PENNDOT e-Notification

BRADD

No. 008

Problem with Shear Stirrup Spacing for Plank Beams

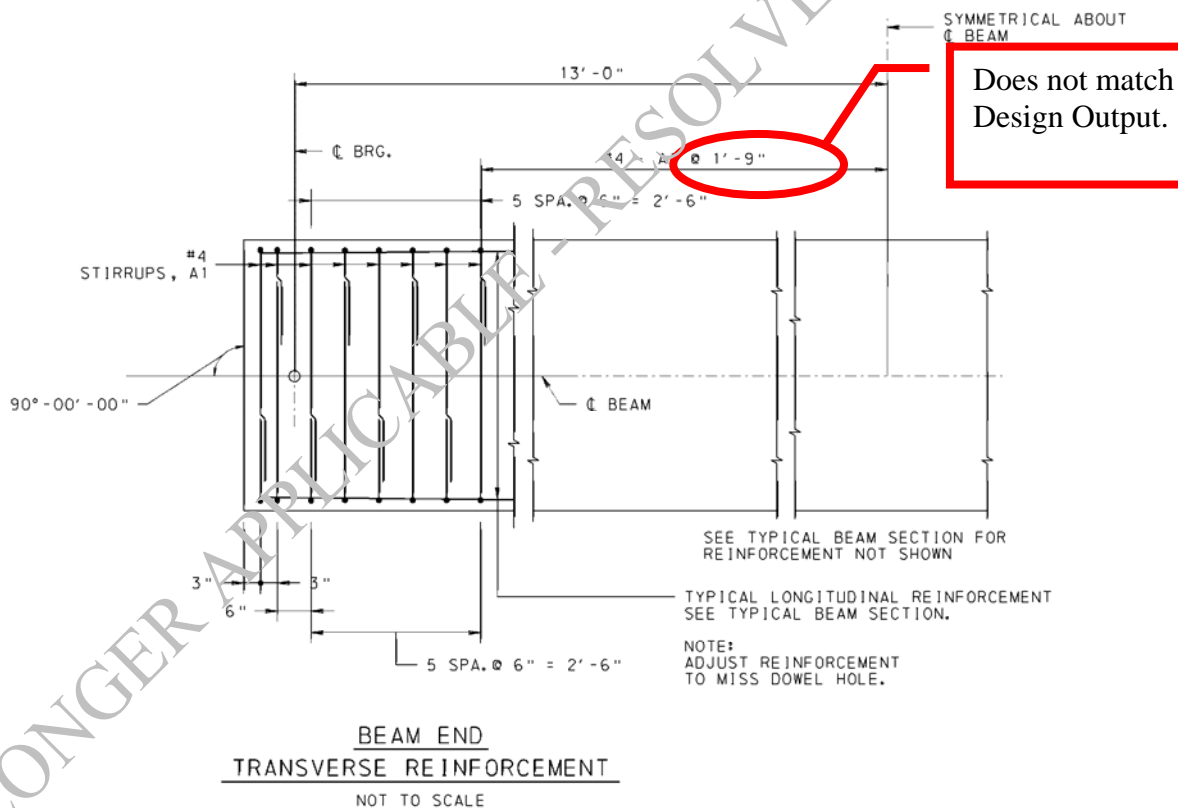
The detailing of the shear stirrup spacing on BRADD generated drawings is not correct for prestressed plank beams. BRADD produces a "BEAM END TRANSVERSE REINFORCEMENT" drawing as shown below. The spacing shown does not match the Design Output spacing.

For this example, the BRADD design drawings should be #4 - A1 @ 6" instead of #4 - A1 @ 1'-9".

For all BRADD jobs that use the 12" prestressed plank beam, the Designer must modify the BRADD generated drawings to match the results from the PSLRFD design output files.

BRADD will be corrected for this problem as a part of the next release of BRADD.
